**Consumers
Power
Company**

MIDLAND ENERGY CENTER GWO 7020
MEETING NOTES FOR APRIL 7, 1983, AND MARCH 7-8, 1983
DISCUSSIONS BETWEEN CPCO AND NRC
File: 0485.21 UFI: 42*05*22*04 Serial: CSC-6661
50*31*01

Notes of Telecon with NRC on April 5 & 7, 1983.

Subject: Soils Remedial Work, Auxiliary Building Underpinning Design Documents.

PIER LOAD TEST DATA ^{TOP} LOAD VERSUS SETTLEMENT

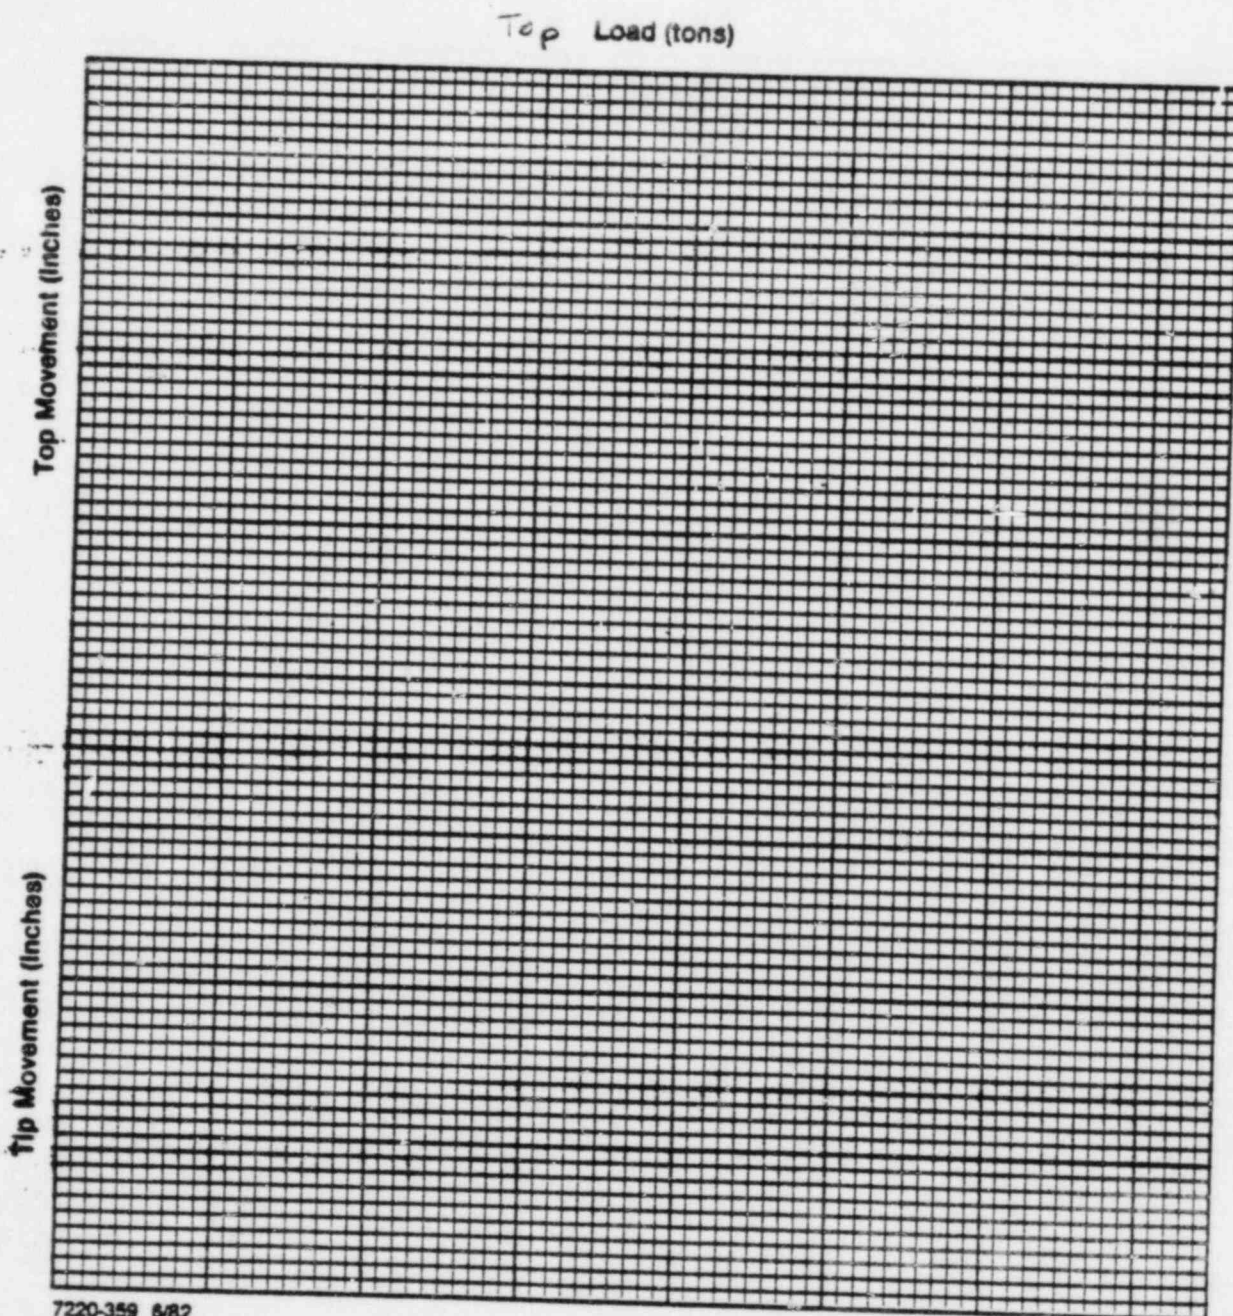
- 6.8 Plots of (a) ^{top} load versus average ^{tip and average} top settlement, (b) ^{tip} load versus average tip settlement, and (c) settlement versus time will be maintained by the RGE to monitor the progress of the test. ^{sample} forms for these plots are attached (Exhibits B_A^C and E_A^F).

- t. Plot of top load versus movement ✓
- u. Plot of tip load versus settlement
- v. Plots of top and tip settlement versus time
- w. Plot of top and tip load ^{indicated} by Carlson ^{stress meters} versus jacking load

PIER LOAD TEST DATA ^{TIP} LOAD VERSUS SETTLEMENT

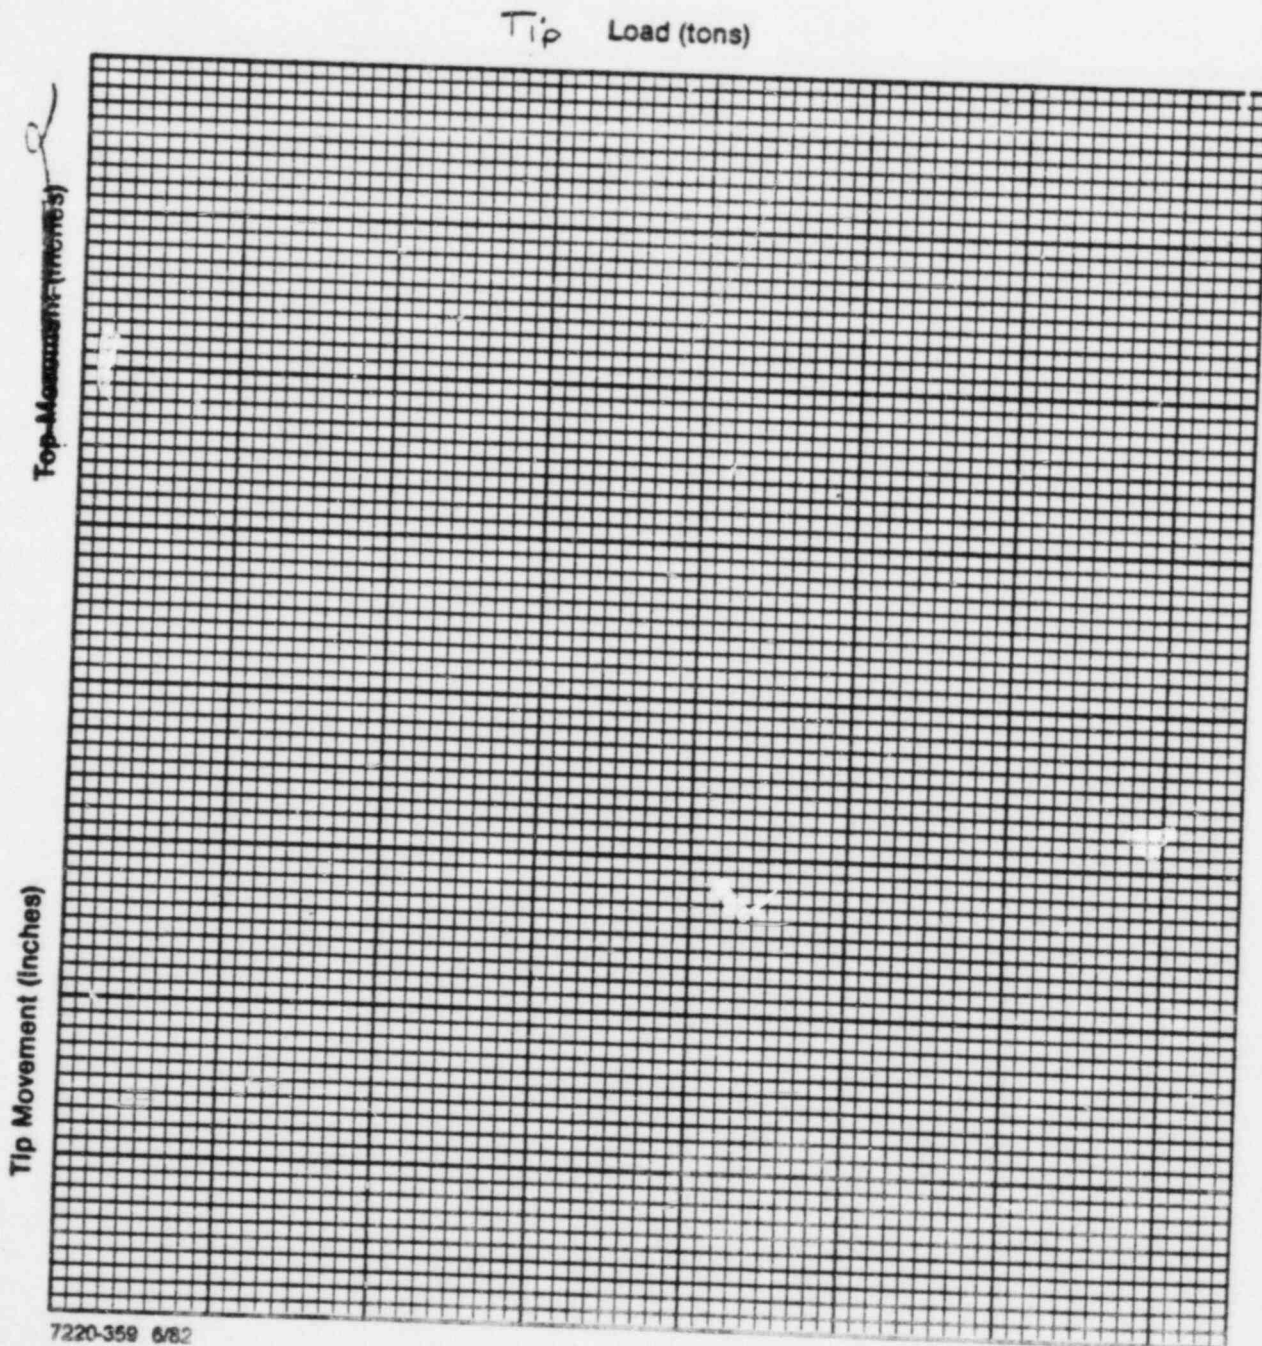
- 10) Page D-7 Sec 8.1 (u) - Insert the word "tip" after "versus".
